DESIGN REVIEW PACKAGE

GILMAN POINT

160 NW GILMAN BLVD, ISSAQUAH, WA 98027

11-05-2014

PARKING

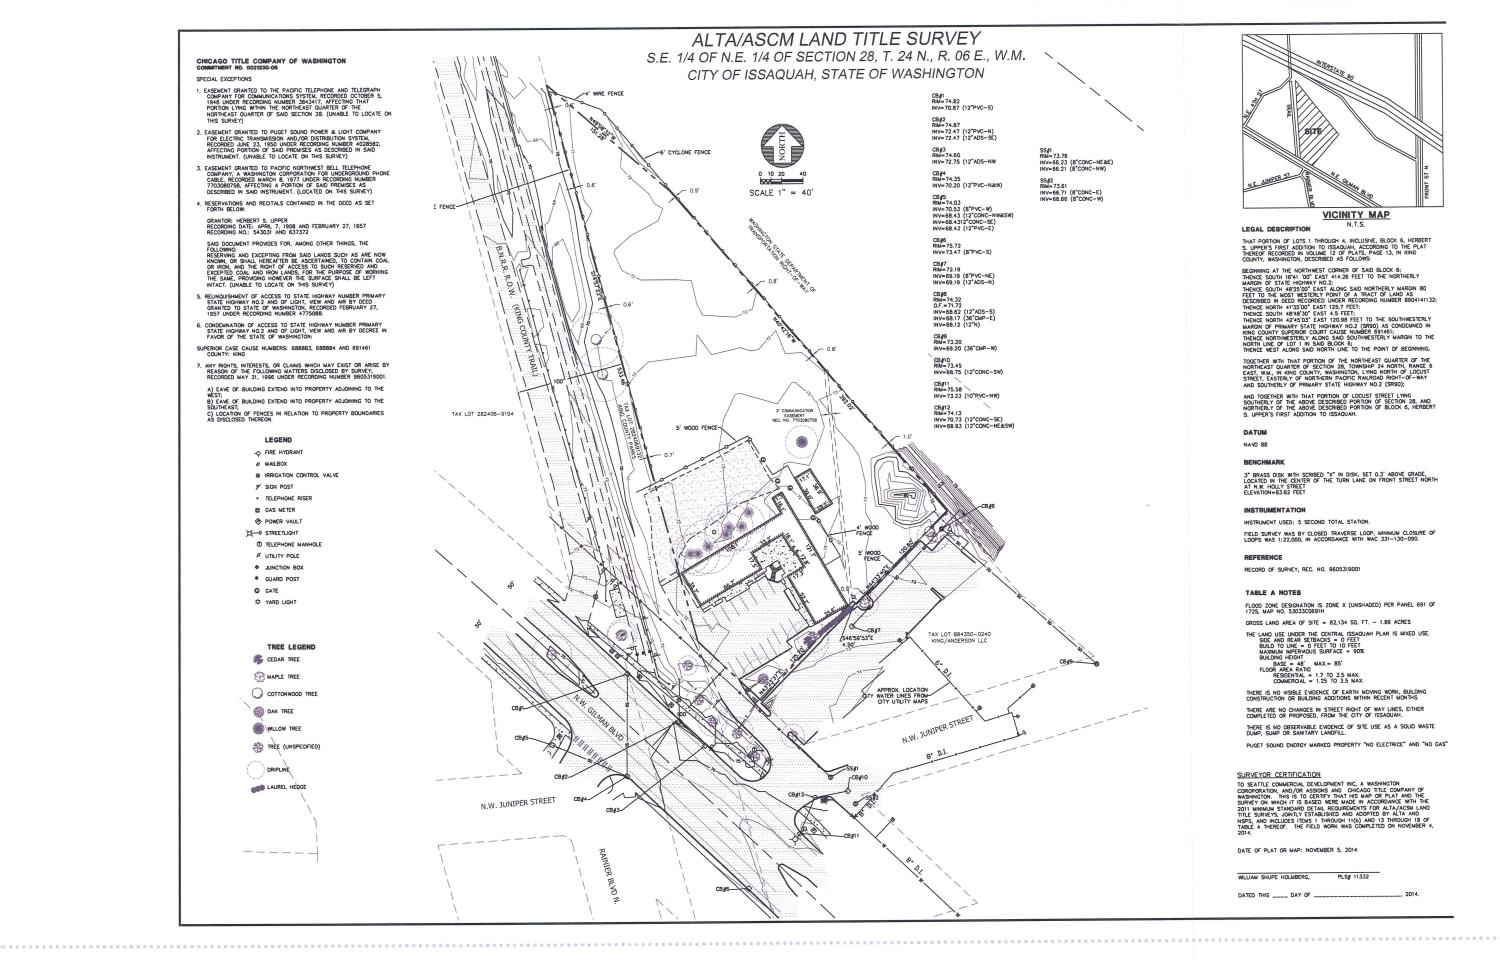
4. Parking: it appears you may have used a parking generation code rather than the CIDDS Chap 8. Please provide calcs using CIDDS showing both the min and max parking allowed and where you fall in that range.

MA: The parking requirements have been updated to reflect the current code. The quantity of stalls has been reduced due to the smaller size Les Schwab. It would appear that we are still below the code required parking. We would request the city consider utilizing some of the 3rd party parking demand studies for the self storage use when reviewing this project.

ARCHITECTURAL SITE PLAN

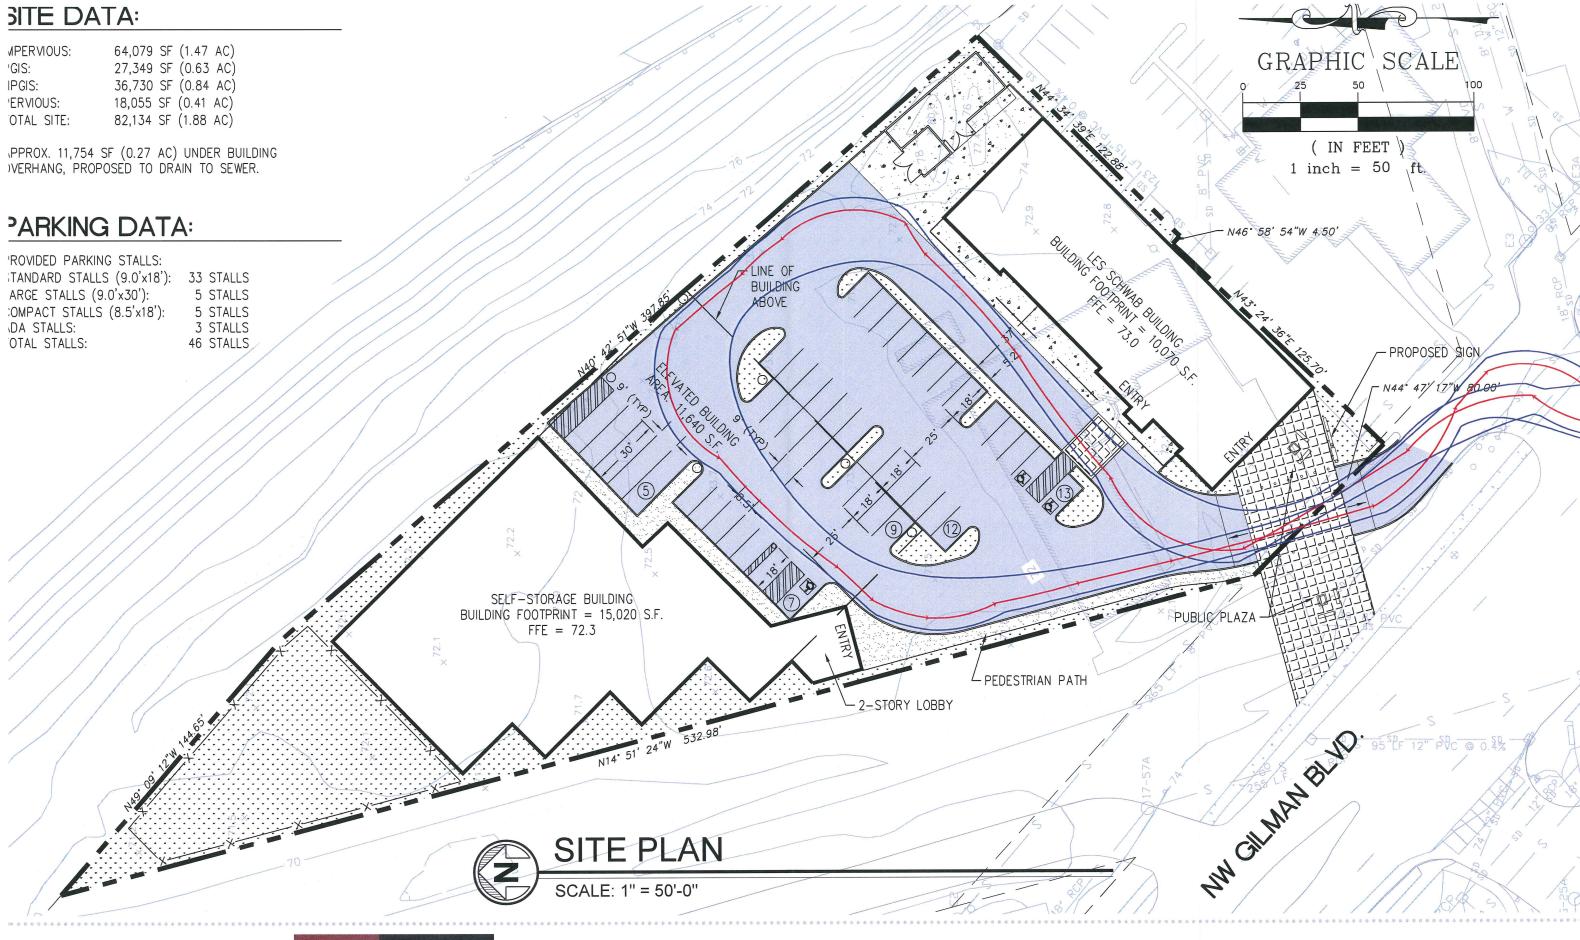
5. Height: please provide height info on the storage building for review relative to CIDDS Table 4.4.

MA: This has been added to conceptual site plan
